Re: DA2021/1756

Please find below a submission to object to the proposed Construction of New Patio Roof at 18P Macpherson Street, Warriewood.

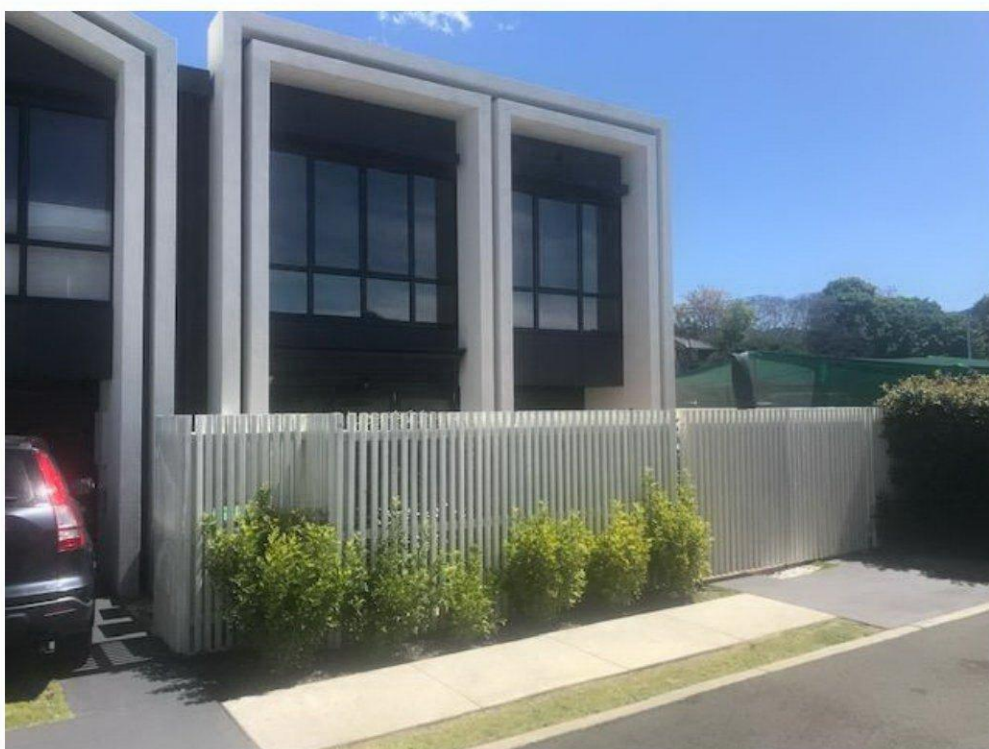
**Comment:** The development proposal does not comply with the CMS. The tree and landscaping have been deleted and replaced with decking and paving. The proposed new patio roof can be seen outside the lot. It will not be in keeping with the essence, streetscape and articulation of the existing dwellings in the development. Please also note the tree planting in each lot except the subject lot where the tree has been deleted. Photos below.

Further, each dwelling in the development has been provided with retractable awnings that cover a good proportion of allocated private open space. The proposed development is to effectively change the use of the existing internal driveway that has been deleted and replaced with a surface more resembling a patio. This has consequences for car parking which is also a matter that will need to be resolved. Cars are regularly illegally parked at the end of the public road which contravenes the CMS, interferes with swept paths for turning circles and most importantly, prevents access to a fire hydrant. You can't park within 1m of a fire hydrant or fire hydrant indicator.

### Solar Access (D16.9)

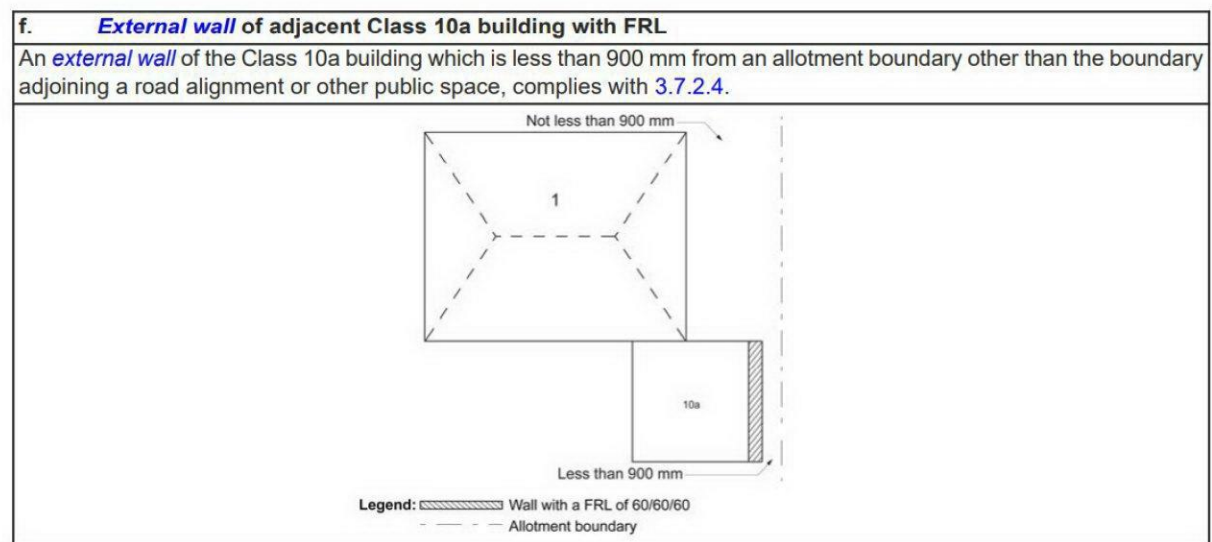
The extent of shading impact will be more significant during the winter months. There may be increased interruption to winter sun penetrating into private open space (rear courtyard) due to the close proximity of the proposed structure and roof height. No shadow diagrams have been submitted.

#### 3.7.2.5 Class 10a buildings

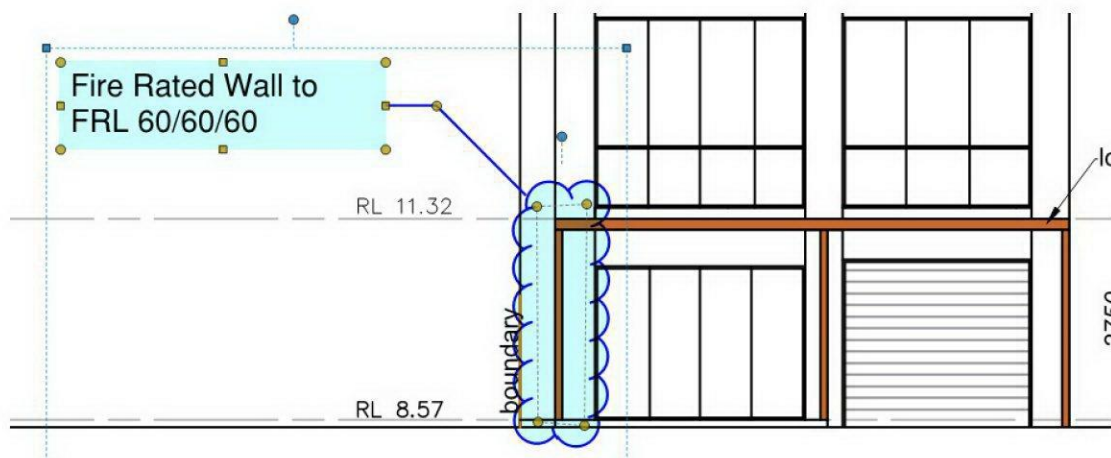
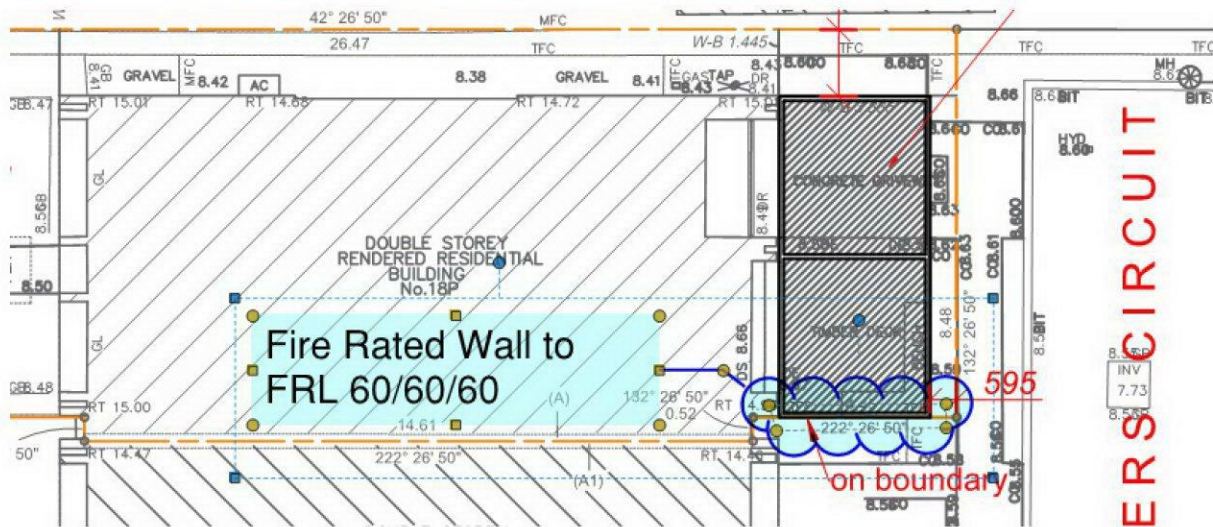
The proposed roofed patio is class 10a under NCC 2019 Volume 2. You can't build a class 10a structure within 900mm of a lot boundary if it is attached to a Class 1a dwelling house unless it is protected by a 'Deemed-to Satisfy' fire rated wall to FRL60/60/60: NCC Excerpt:

**Comment:** There has been no consideration for NCC requirements in the design prior to DA lodgement which is a common mistake made by architects and designers and can often compromise the development.

A 2850mm masonry wall on the boundary will have a towering effect on my property and will not be in keeping with the streetscape. The wall would need to be built wholly within the subject lot boundary.
